File No –B-751 (439)/Textile/WQM-II/CPCB/2017-18

Subject: Verification of implementation/compliance status of M/s Kanpur Texel Pvt. Ltd., Dada Nagar Kanpur to CPCB directions issued dated 04.09.2018 –reg.

**REPORT
ON
ADEQUACY ASSESSMENT OF EFFLUENT
TREATMENT PLANT ON PHYSICAL BASIS FOR
THE CLOSED UNIT**

For
**M/s KANPUR TEXEL (P) Ltd.
12-B-3, Dadanagar, Co-Op Industrial Estate
Kanpur - 208022
July 2018**

Fig: 2 Flow Diagram of ETP

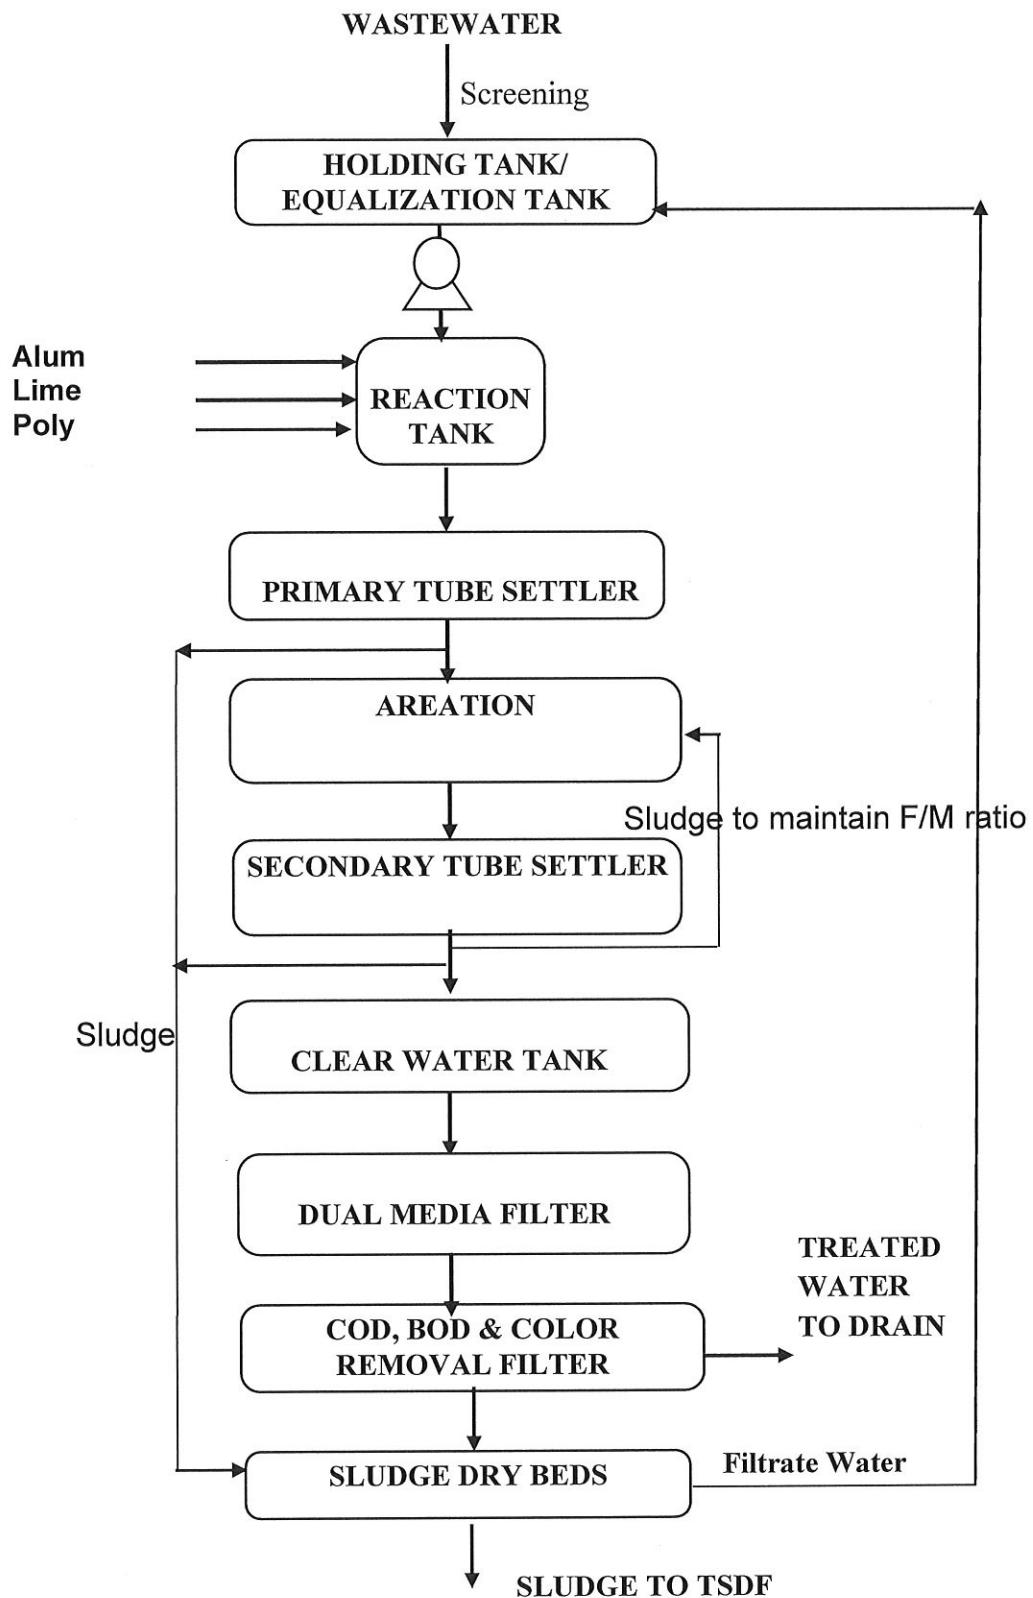
The unit has installed Effluent Treatment Plant to treat the wastewater. The wastewater treated in a continuous operation. The wastewater from different sources is collected in a holding cum equalization tank by gravity through screening process. The collected wastewater then sent to reaction tank by pump where Lime, Alum and poly added by dosing pumps to neutralize the pH and maintain physical characteristics of wastewater. Agitator is provided for the proper mixing of chemicals. The wastewater overflows from reaction tank and came into the primary tube settler. The wastewater overflows into open channel and sent to Aeration tank. Where air (or oxygen) injected through diffuser in the mixed liquor by maintaining the F/M ratio and MLSS. Alive bacteria of sludge is again used in aeration to utilize this bacteria. After that the wastewater transferred to secondary tube settler to allow the biological flocs to settle down, thus separating the biological sludge from the clear treated water. The settled sludge is taken to sludge drying bed by gravity from both the tube settlers. The filtrate from the sludge dry bed recycled to the Equalization tank. The treated water from secondary tube settler overflows to the clear water tank and discharged to the municipal drain via dual media filter and colour removal filter. For disposed-off the generated sludge by the unit is collected through the TSDF facility. The unit has Membership of Bharat oil and Waste Management Ltd.

Based on the pollution load on ETP and required capacity of its each component, adequacy of respective component of existing ETP has been assessed below.

Therefore, the ETP is adequate to treat the wastewater generated from the unit.

- ✓ The dosing of Urea and DAP in Aeration tank should be done for reducing the BOD and COD content.
- ✓ The unit is required to keep the unit in continuous operation for sustain life of active Biomass in the activated sludge process
- ✓ The unit should ensure proper calibration of online continuous effluent monitoring system and also advised that the manual monitoring of treated effluent at regular interval shall be performed.
- ✓ Kindly ensure the naming of each components of ETP.
